MONTGOMERY COUNTY HISTORIC PRESERVATION COMMISSION
STAFF REPORT

Address:	3 Newlands Street., Chevy Chase	Meeting Date:	04/19/17
Resource:	Contributing Resource Chevy Chase Village Historic District	Report Date:	04/12/17
Applicant:	Kathryn Everette	Public Notice:	04/05/17
Review:	HAWP	Tax Credit:	N/A
Case Number:	35/13-17I	Staff:	Dan Bruechert
Proposal:	Alterations to garage and new rear entrance

PROPOSED LEFT ELEVATION

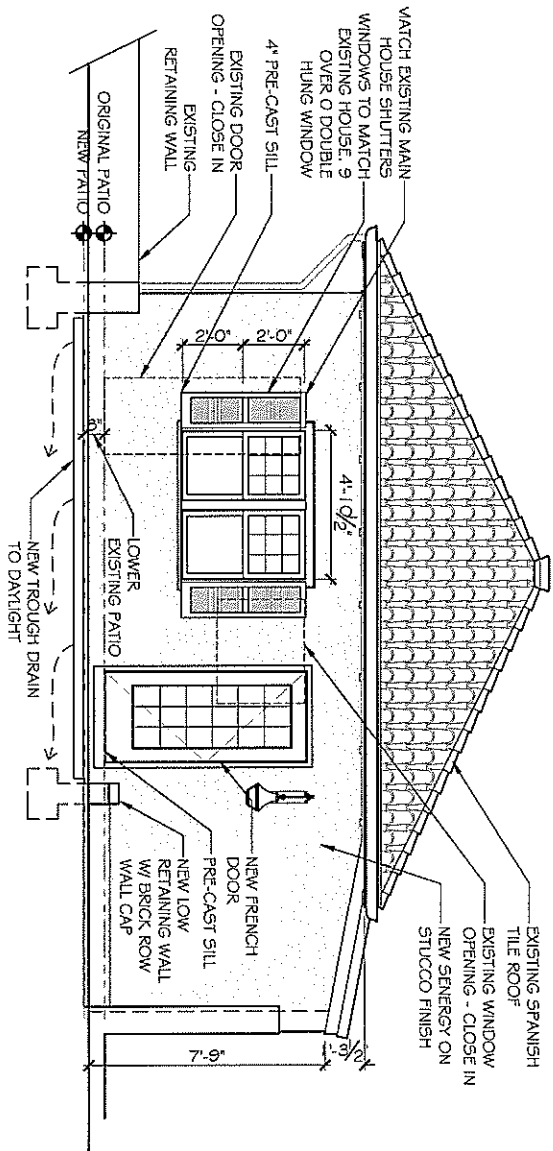
The left elevation, which faces the neighboring lot, is to enclose an existing window opening and stucco over the opening. The right elevation will be reconfigured to have a pair of sash windows that match the configuration found throughout the house with shutters to match. Additionally, the right elevation will also receive a new full-lite French door. The only change to the rear, which is not visible from the public right of way, is a new coating of stucco. All of the changes proposed for the elevations that are not visible from the public right of way are in keeping with the Design Guidelines and comply with Chapter 24A.

PROPOSED BASEMENT PLAN

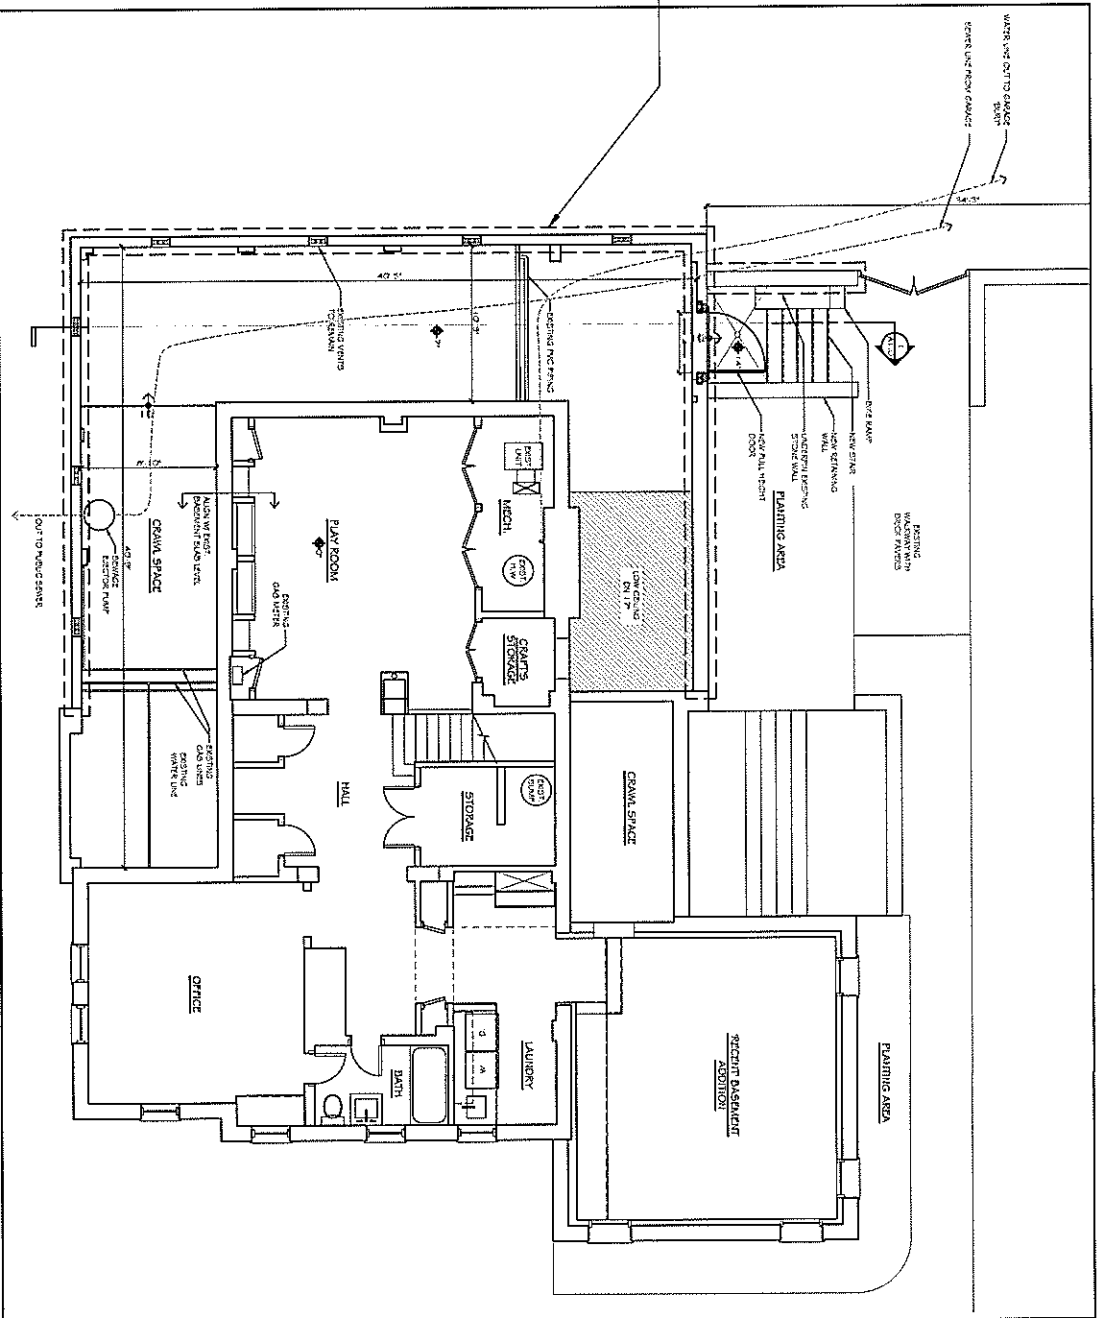
The applicant is proposing to lower the floor level of the crawlspace at the northeast corner of the house. To accommodate the new crawlspace level, the applicant is proposing changing an at-grade, half-height door, to a full height door accessed via several steps down. A brick retaining wall is proposed at each side of the steps. The full height door will retain the character of the historic, and will be half-glass with a four-panel cross below. Like the garage, rear doors and entrances are to receive lenient scrutiny when they are not visible from the public right-of-way. The scale and details of the proposed new rear door and opening are in keeping with the massing and scale of the historic house and should be approved.
